DESIGN #	DRAWN BY CP	DART AEROSPACE LTD HAWKESBURY, ONTARIO, CANADA	
CHECKED #	APPROVED #	DRAWING NO. DSI 9280	REV. A SHEET 1 OF 1
DATE 04.05.04		TITLE SUPPORT MODIFICATION	SCALE NTS
A	04.05.04	NEW ISSUE

**DART SERVICE INSTRUCTION**  
**TO AMEND INSTALLATION INSTRUCTIONS IIN-D212-664 REV. B**  
REF. CANADIAN STC: SH01-9 ISSUE 2  
REF. FAA STC: SH01298NY

D2896-1  
SUPPORT

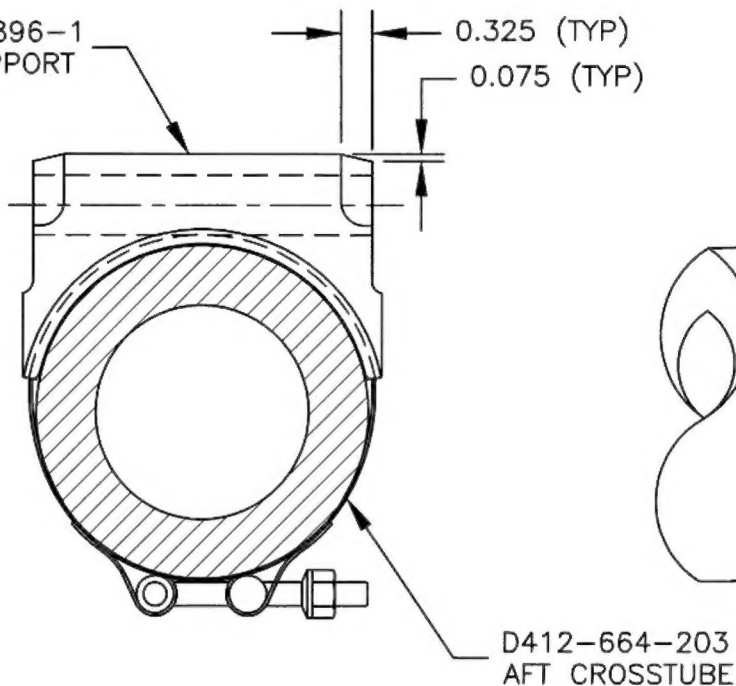
To prevent rocker beam interference during installation of D412-664-203 Crosstubes, it is permissible to relieve the D2896-1 Support as shown below. Touch-up with primer & paint per ICA-D212-664.

0.325 (TYP)  
0.075 (TYP)
